From: DOAN Trung V
Sent: Thursday, 12 November 2015 10:59 AM
To: DAVE Gopang
Cc: CHIM Kevin; McMahon, Anthony; KROLL Ian
Subject: RE: Sydney Metro Northwest -DL85.21 - Temporary Works - Launching Gantry Steel Tower Temporary Support for Piers 92 to 94 in Southern Bus Layover (FDD)
Attachments: NWRLSVC-HYD-SVC-DN-CRR-852100.A.FR - RMS Bridge Comment.xlsx

Item	Document Number	Description	Rev	Status	Type	Design Lots
1.	NWRLSVC-ISM-BVR-CS-DRT-852100	SOUTHERN BUS LAYOVER PIER 92 TO 94 LAUNCHING GANTRY STEEL TOWER TEMPORARY SUPPORT DESIGN REPORT	A	FDD	DRT	DL85
2.	NWRLSVC-ISM-SVC-CS-DRG-852100	SOUTHERN BUS LAYOVER - TEMPORARY WORKS SET DRAWING INDEX	B	FDD	DRG	DL85
3.	NWRLSVC-ISM-SVC-CS-DRG-852102	SOUTHERN BUS LAYOVER - TEMPORARY WORKS SET PIER 92 STEEL TOWER TEMPORARY SUPPORT	B	FDD	DRG	DL85
4.	NWRLSVC-ISM-SVC-CS-DRG-852103	SOUTHERN BUS LAYOVER - TEMPORARY WORKS SET PIER 93 STEEL TOWER TEMPORARY SUPPORT	B	FDD	DRG	DL85
5.	NWRLSVC-ISM-SVC-CS-DRG-	SOUTHERN BUS LAYOVER - TEMPORARY WORKS SET PIER 94 STEEL TOWER TEMPORARY SUPPORT	B	FDD	DRG	DL85

Topic: Roads and Maritime Services' response to Sydney Metro's request to continue constructing an elevated viaduct over White Hart Drive, Rouse Hill.

NORTH WEST RAIL LINK	
44km690 TO 44km810	
SOUTHERN BUS LAYOVER - TEMPORARY WORKS SET	
PIER 92 STEEL TOWER TEMPORARY SUPPORT	
STATUS: FINAL DESIGN DOCUMENTATION	SHEET 2 OF 9
NWRL Dwg No. NWRLSVC-ISM-SVC-CS-DRG-852102	NWRL REV. B.1

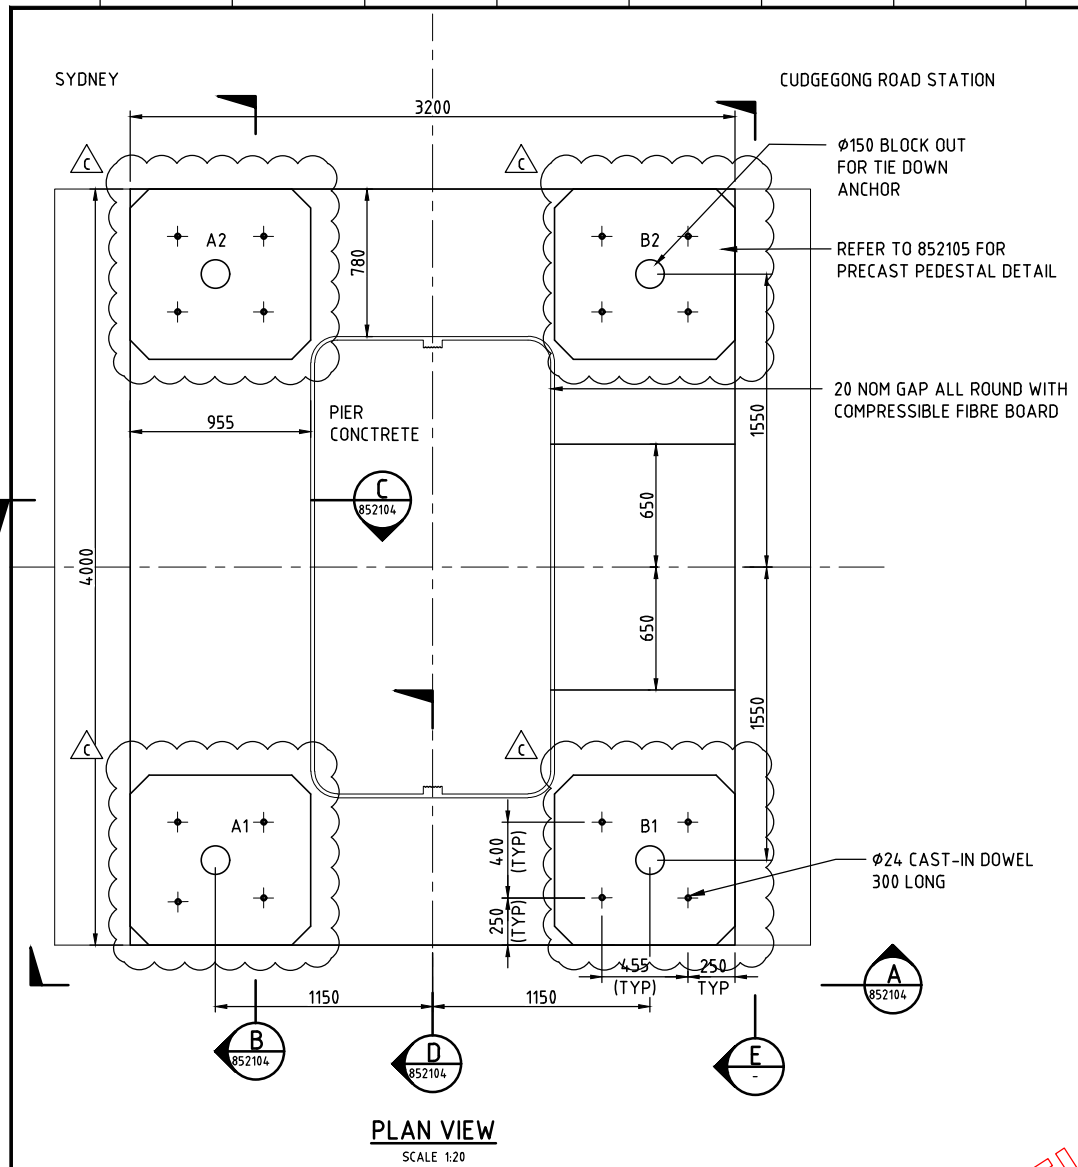
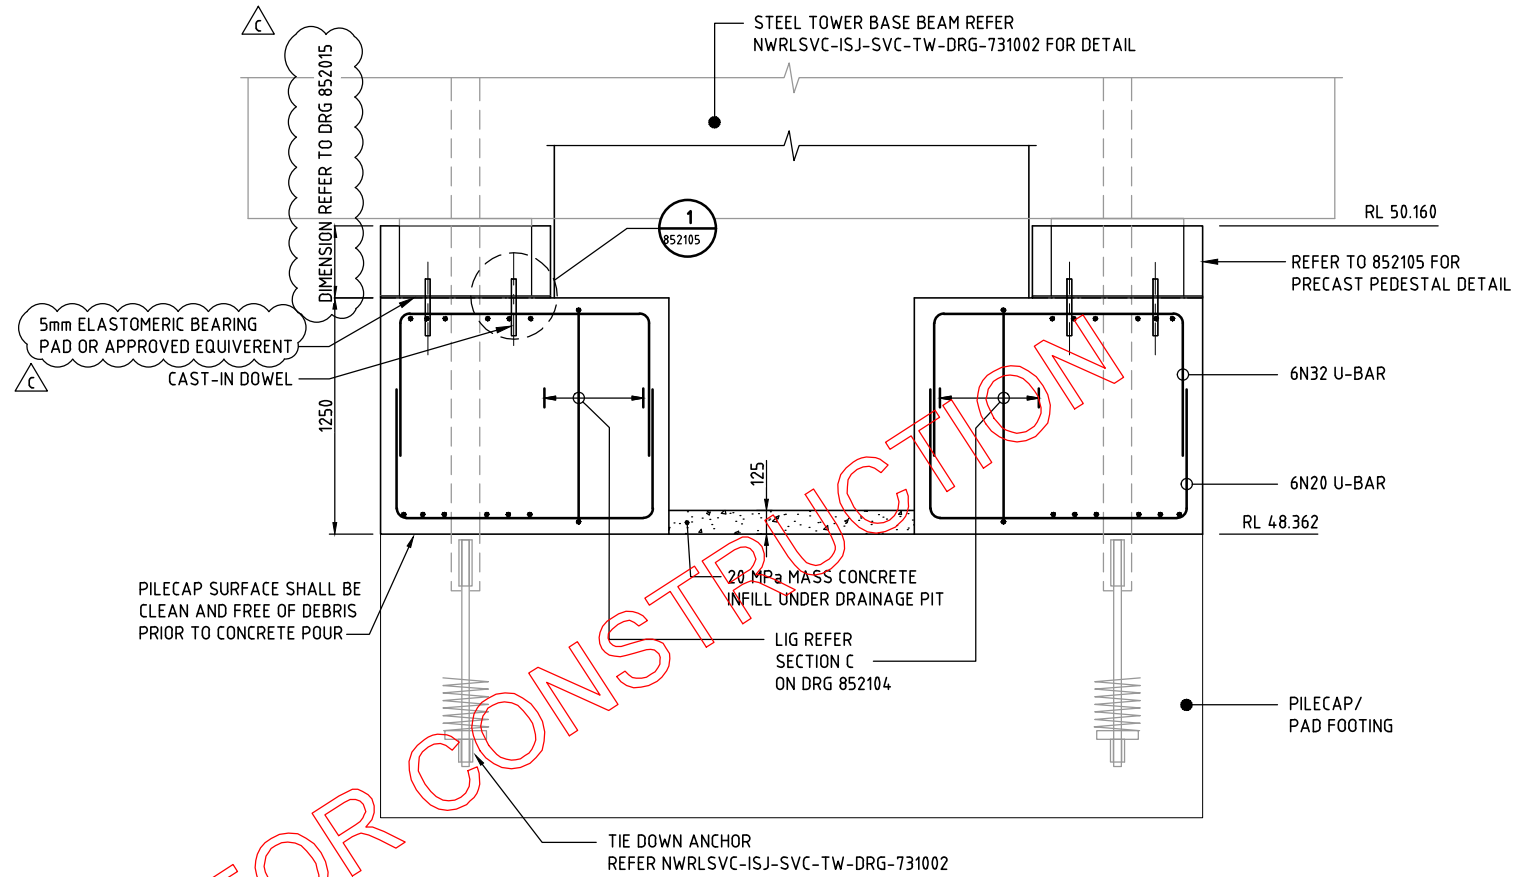
3	FDD	DL85.21	A	TD	12-Nov-2015	Bridge	RMS	Report	Section 6: there are numerous notes about the piles, pile caps and breakdown of piles but these elements are not shown on the drawings. Please clarify		O						
4	FDD	DL85.21	A	TD	12-Nov-2015	Bridge	RMS	Drawings	Sheet 2 -5: the cast in dowels appear to be cut-off and left in place. Therefore they should be stainless steel.		M						
5	FDD	DL85.21	A	TD	12-Nov-2015	Bridge	RMS	Drawings	Sheet 8: Stage 2 - it should be noted on this drawings that the footing / pile cap to be thoroughly inspected after the completion of the temporary works for any cracking or defect before backfilling. It may be useful to carry out a survey of the footing / pile cap to ascertain it has not moved or settled during the temporary works.		M						
6	FDD	DL85.21	A														
7	FDD	DL85.21	A														
8	FDD	DL85.21	A														
9	FDD	DL85.21	A														
10	FDD	DL85.21	A

NORTH WEST RAIL LINK	
44km690 TO 44km810 SOUTHERN BUS LAYOVER - TEMPORARY WORKS SET PIER 94 STEEL TOWER TEMPORARY SUPPORT	
STATUS: FINAL DESIGN DOCUMENTATION	SHEET 4 OF 9
NWRL Drg No: NWRLSVC-ISM-SVC-CS-DRG-852104	NWRL REV: B.1

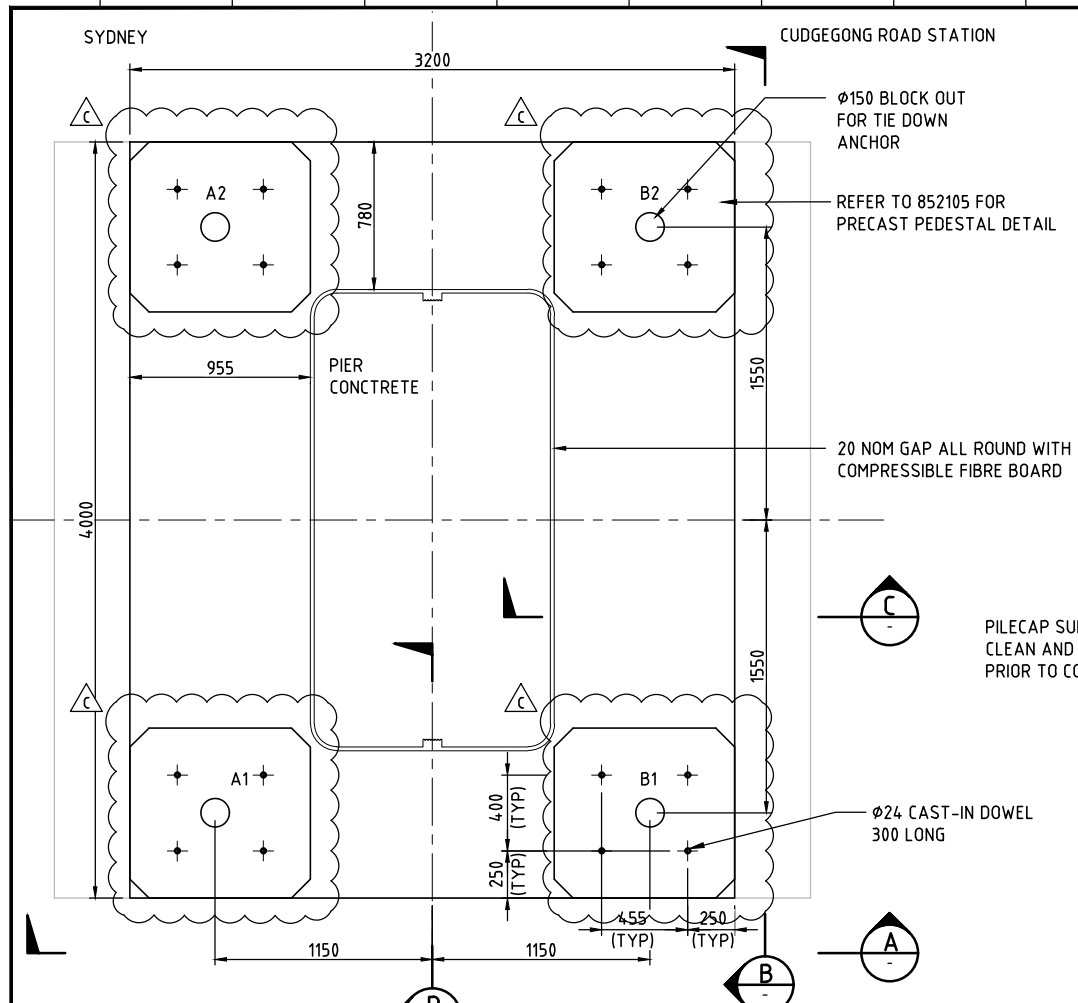
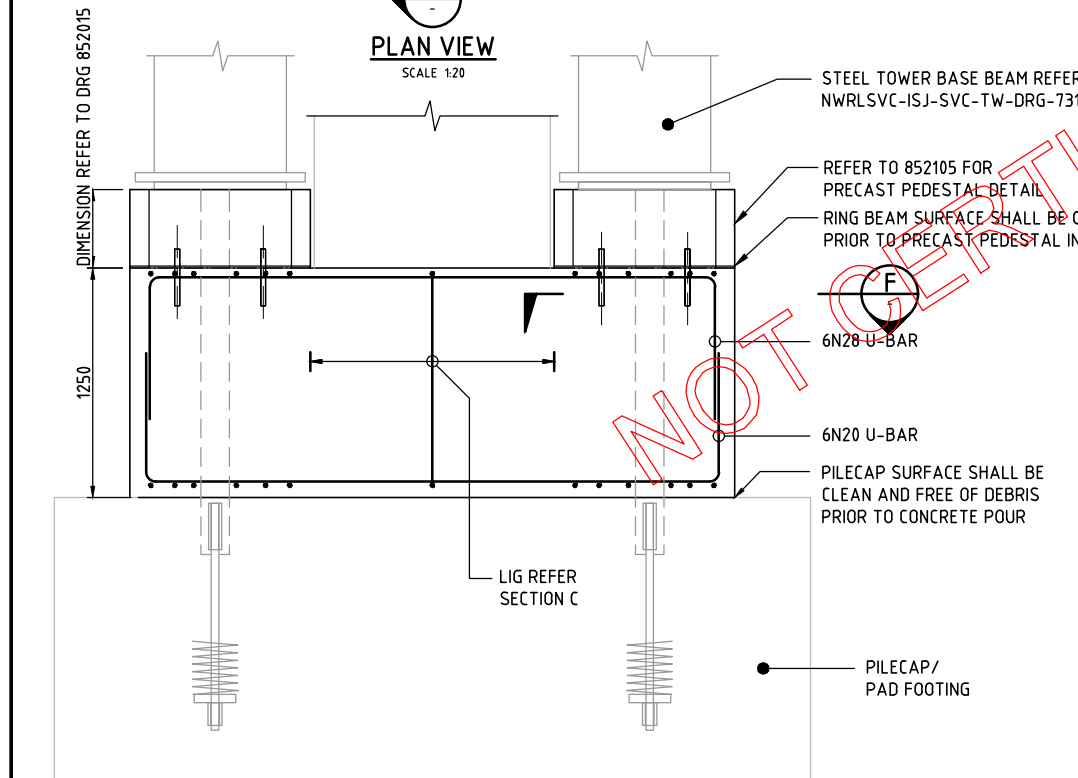
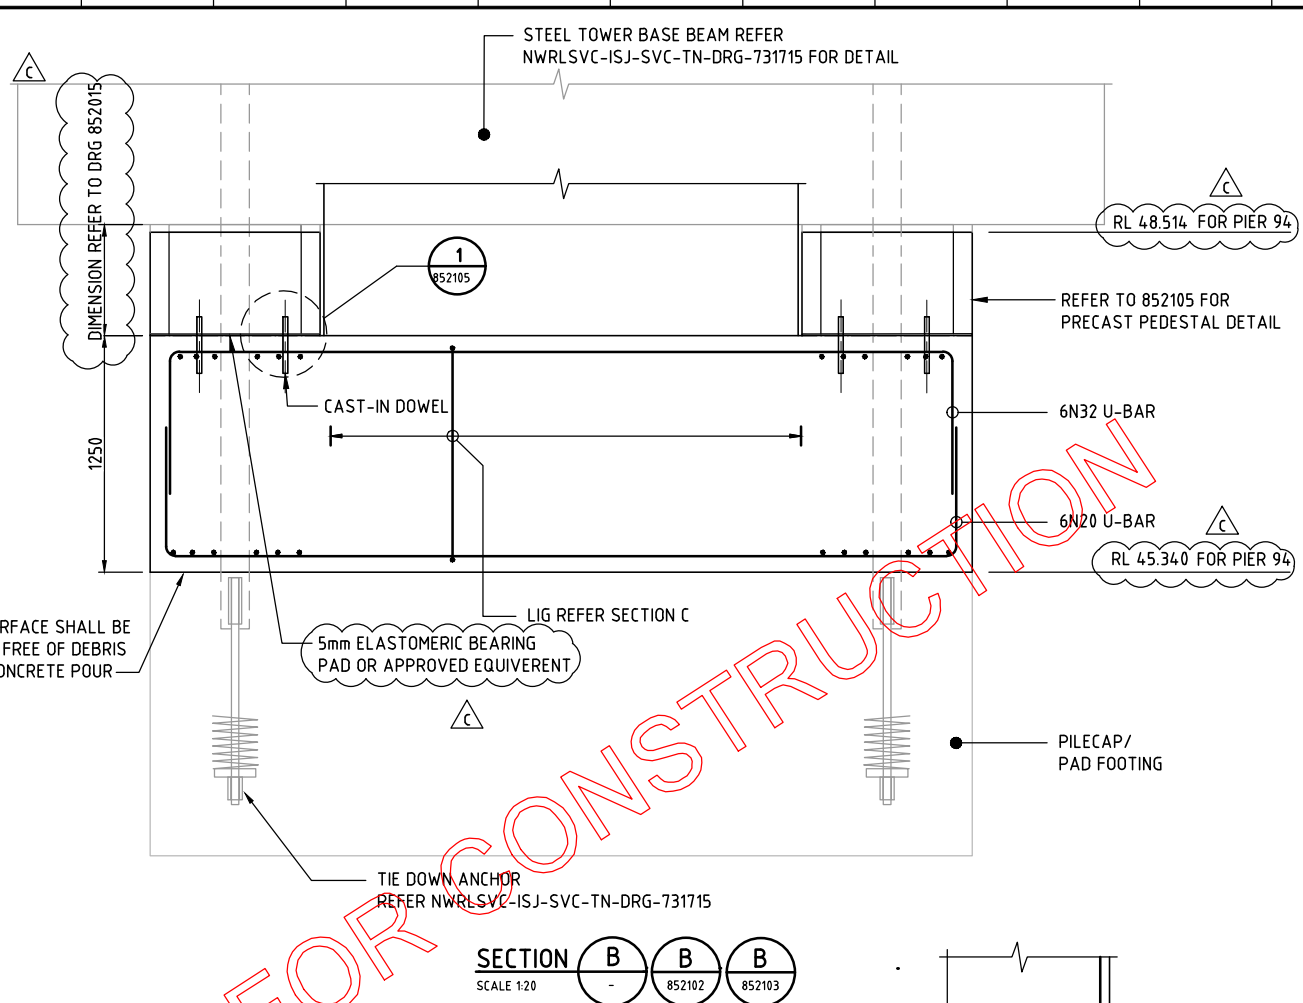
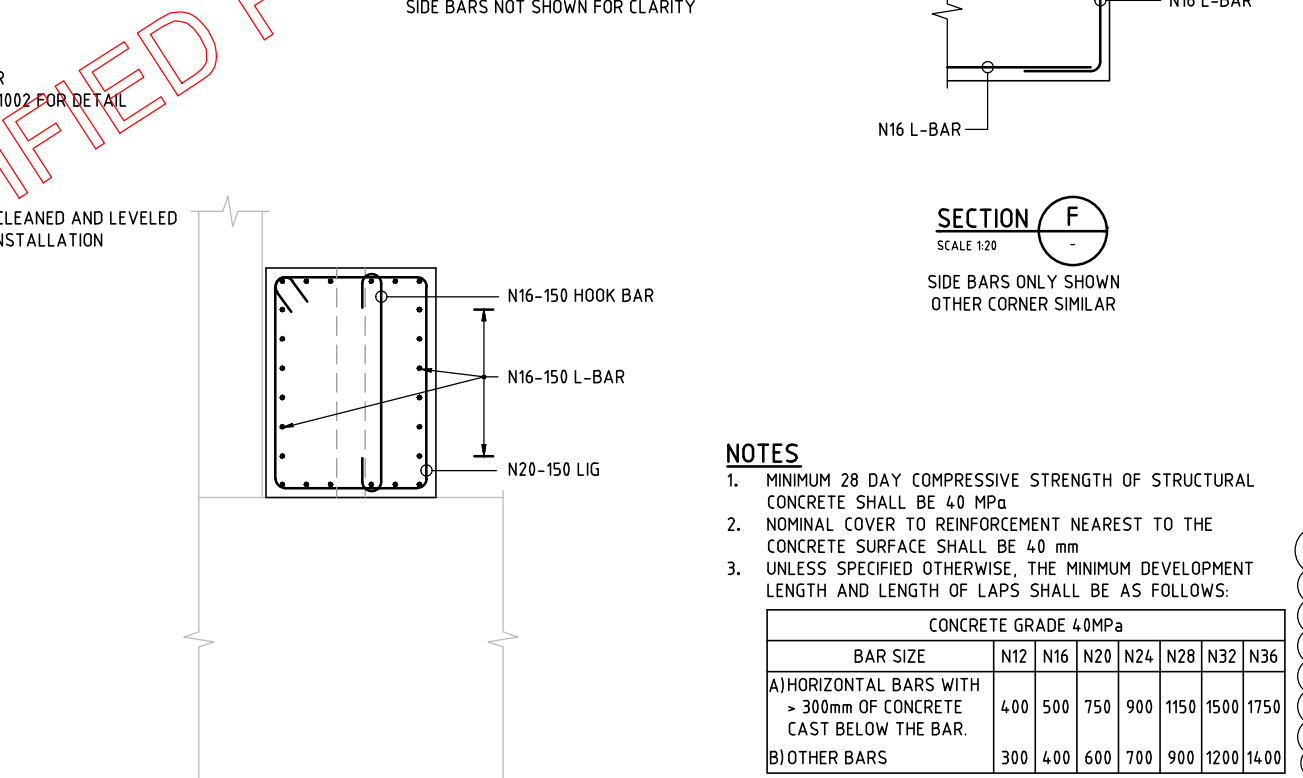
33	FDD	DL85.21	A	TD	12-Nov-2015	Bridge	RMS	Drawings	Sheet 2 - 5: the cast in dowels appear to be cut-off and left in place. Therefore they should be stainless steel.		M	C.Ng: A note has been added on drawing 852104 to ensure the cut dowel is to be coated by epoxy resin.	19/11/2015					Closeout Check Print provided
34	FDD	DL85.21	A	TD	12-Nov-2015	Bridge	RMS	Drawings	Sheet 6: Stage 2 - It should be noted on this drawings that the footing / pile cap to be thoroughly inspected after the completion of the temporary works for any cracking or defect before backfilling. It may be useful to carry out a survey of the footing / pile cap to ascertain it has not moved or settled during the temporary works.		M	C.Ng: Noted. This note has been added on drawing 852104.	19/11/2015					Closeout Check Print provided
35	FDD	DL85.21	A	IK	13-Nov-2015	Pavement	RMS	Drawings	Provide copy of drawing referred in Note 1 of DRWG No. 852106 and 852107. This will allow comparison of the permanent pavement joints and the Stage 2 pavement joints on the drawings submitted for review.		D	B.Basso: Note the latest drawing series NWRLSVC-ISM-SRH-RE-DRG-255300 is accessible on TeamBinder. These drawings within this series range from NWRLSVC-ISM-SRH-RE-DRG-255331 to NWRLSVC-ISM-SRH-RE-DRG-255391.	26/11/2015					Response Only
